**ADDENDUM
NO. 1**

October 18, 2022

Carey Ridge Elementary Addition & Renovation
16231 Carey Road
Westfield, IN 46074

PROJECT: Carey Ridge Elementary School Addition & Renovations

3.5 Sheet S202H – Roof & Mezzanine Floor Framing Plans – Unit H

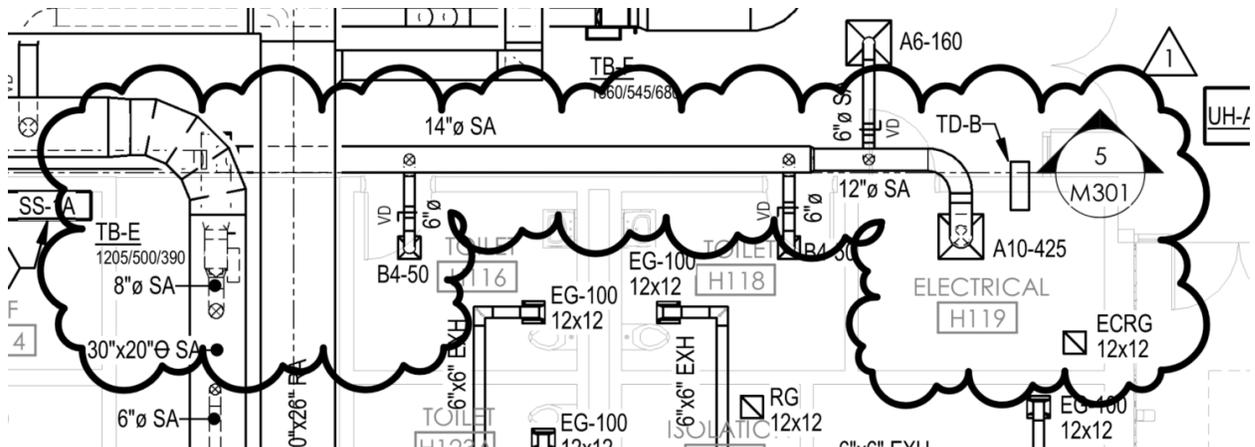
- A. Add a note to the eave along line H4 describing CFS outriggers to support the roof deck along the upper roof edge and add trusses on the lower roof side along the step in the roof as shown on the attached drawing.
- B. Revise the note at the eave between lines HA.5 and HB that describes deck support at the upper roof edge as shown on the attached drawing.
- C. Revise several of the section cuts around the perimeter of the building to reference section sheet S702 instead of S701 as shown on the attached drawing.

3.7 Sheet M501 – Mechanical Details

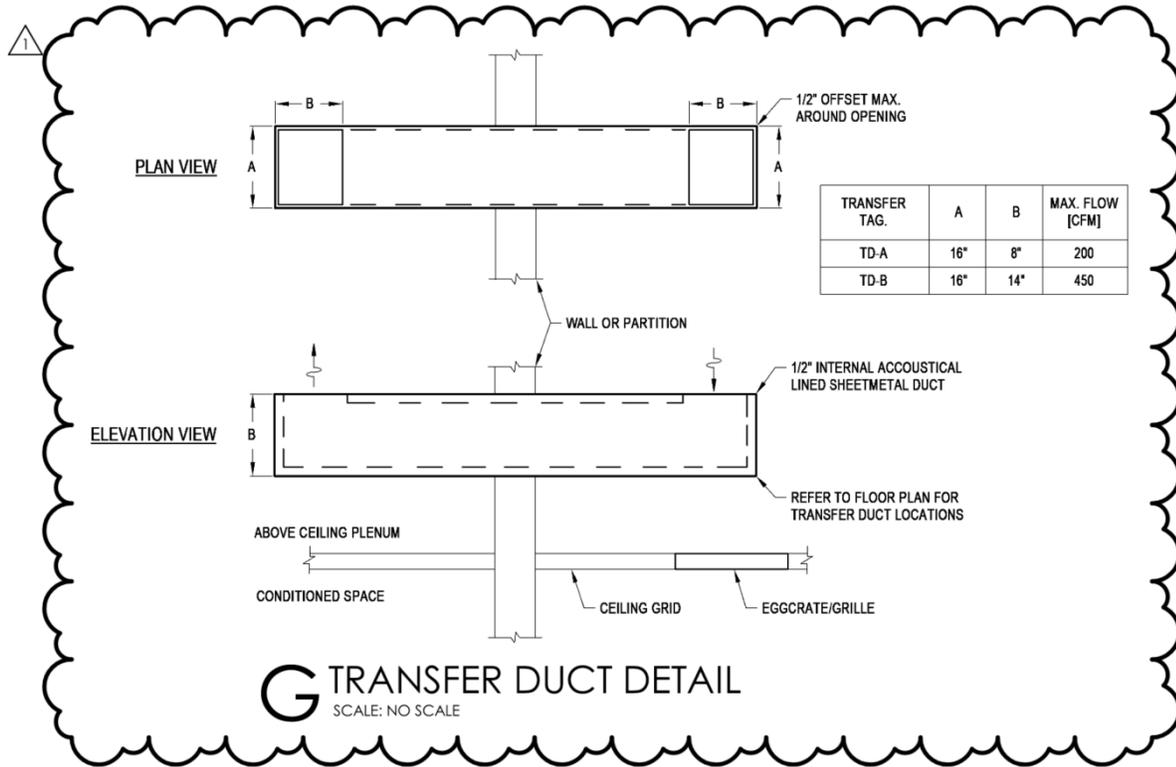
A. Revised detail G Transfer Duct Detail

DRAWING NUMBER
 L101

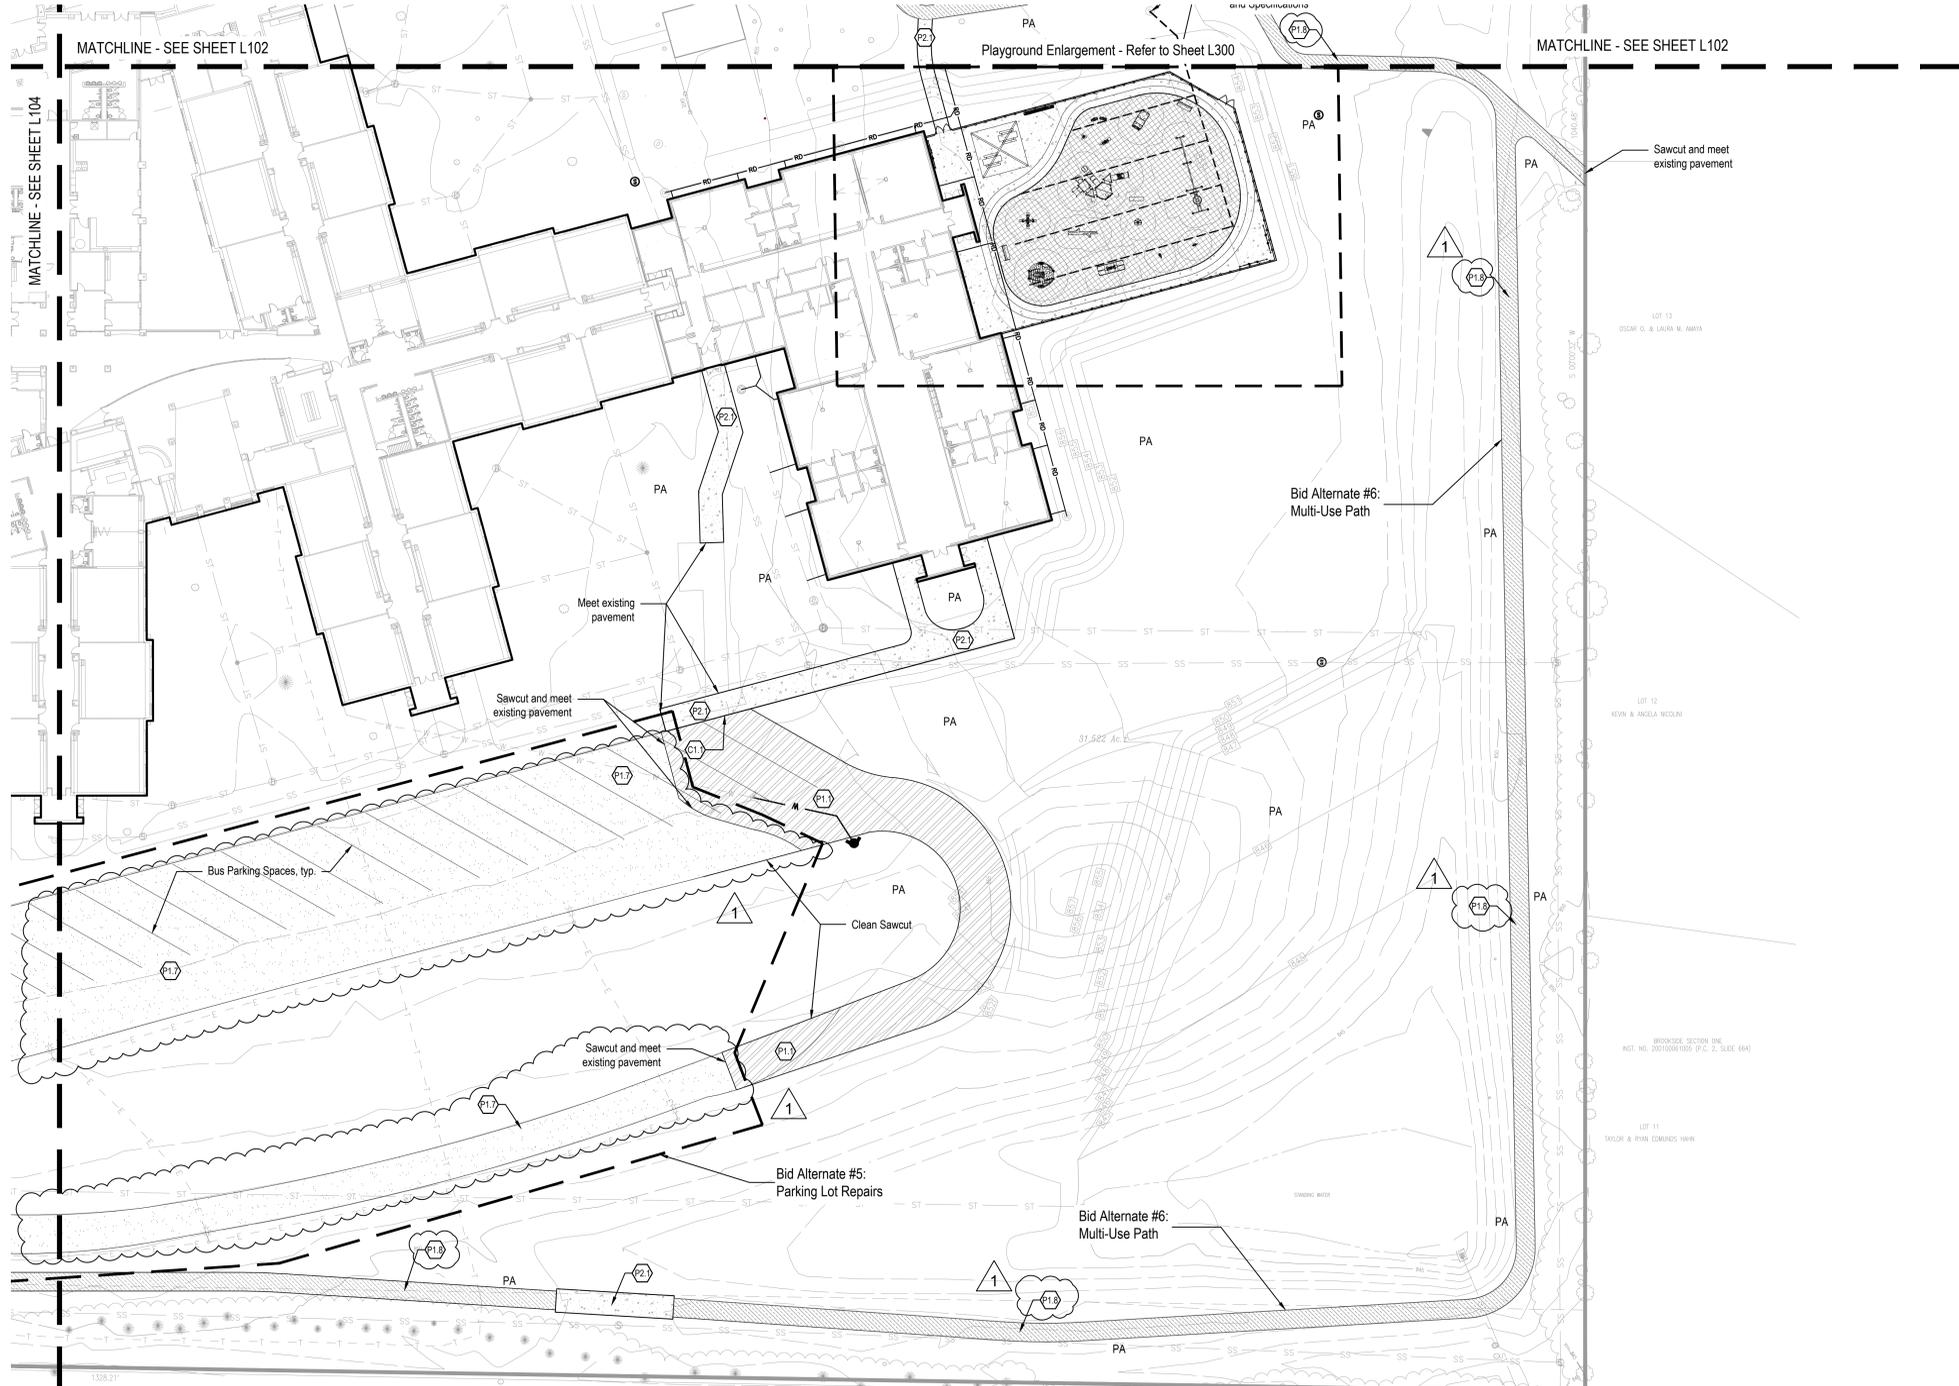
- A. Keynotes P1.8 and P1.9 have been removed, resulting in P1.10 shifting up to P1.8
- B. Hatches have been revised to reflect current paving.
- C. Material Legend reference updates:
 - 1. P1.1 reference detail is now 7/L600
 - 2. P1.2 reference detail is now 5/L600
 - 3. P1.7 reference detail is now 7/L600 and the scope of the keynote has been revised.

6 HEAVY-DUTY ASPHALT PAVEMENT
Not to Scale

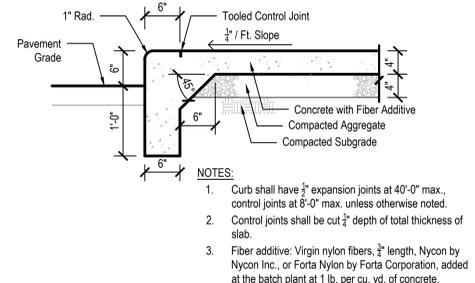
- A. Detail 6/L600, Heavy-Duty Asphalt Pavement, Bituminous Binder #8 changed from 6.5" to 5" in depth. To match Geo-Tech Report.
- B. Detail 7/L600, Asphalt Resurfacing, was replaced with Heavy-Duty Asphalt Pavement (Bus Expansion).
- C. Note has been added: "Pavement Note: For parking areas fully milled to stone, contractor shall re-grade aggregate base to be level prior to new asphalt layers."

PAVEMENT NOTE:
For parking areas fully milled to stone, contractor shall re-grade aggregate base to be level prior to new asphalt layers.
